# Authorized Field Change

**AFC 13916**

**Subject:** MaxxForce® 15 Powertrain Harness Chafing

Model: ProStar®+  
Start Date: 14 January 2011 End Date: 14 August 2012  
Engine Family: MaxxForce® 15

**Figure 3. Powertrain Harness Connection.**

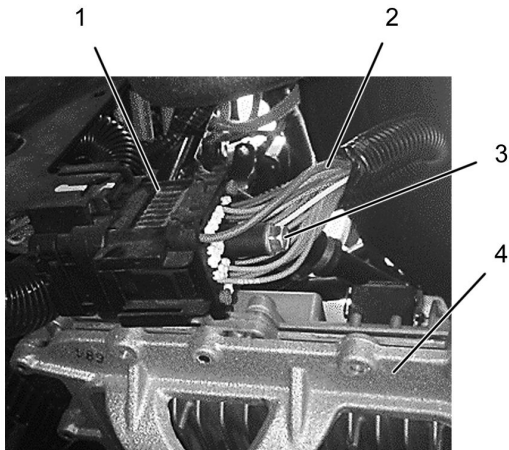
1. Powertrain harness 42-way connector
  2. Powertrain harness circuit wires
  3. Center post bolt
  4. ECM
6. Inspect powertrain harness circuit wires (Figure 3, Item 2) for signs of chafing at ECM (Figure 3, Item 4).
- a. If no chafing is found, proceed to Step 7.
  - b. If wires are chafed but copper is not exposed, install heat shrink over damaged circuit wires.
  - c. If wires are chafed and copper is exposed, follow steps below.
    1. Splice in new circuit wires.
    2. Install heat shrink over splices.
7. Disconnect powertrain harness 42-way connector (Figure 3, Item 1).
8. Remove center post bolt (Figure 3, Item 3).
9. Install backshell (Figure 2, Item 1).
10. Install center post bolt. Using torque wrench, tighten post bolt to 31 lb-in (2.6 N•m).

**Figure 4. Repaired Powertrain Harness 42-Way Connector.**

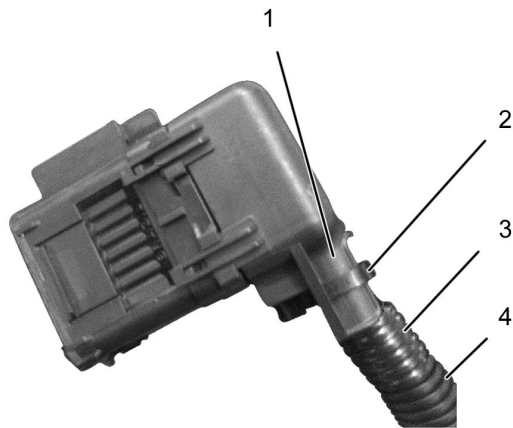
11. If needed, add convoluted tubing (Figure 4, Item 4) to cover exposed harness wires up to backshell body extension (Figure 4, Item 1).
12. Tape joints and ends (Figure 4, Item 3) of convoluted tubing, if installed.
13. Tie-wrap (Figure 4, Item 2) backshell extension.

**Figure 5. Powertrain Harness.**

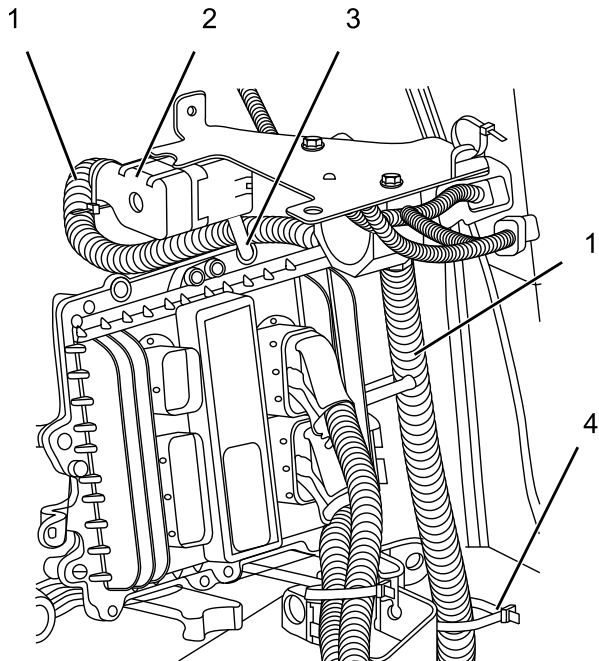
- 14. Connect powertrain harness 42-way connector (Figure 5, Item 1).
- 15. Route powertrain harness (Figure 5, Item 2) toward cab and behind ECM as shown in Figure 5, and secure powertrain harness (Figure 5, Item 2) with fir tree strap (Figure 5, Item 3) and cable tie strap (Figure 5, Item 4).
- 16. Connect negative battery cable.
- 17. Close and latch hood.
- 18. Remove wheel chocks.
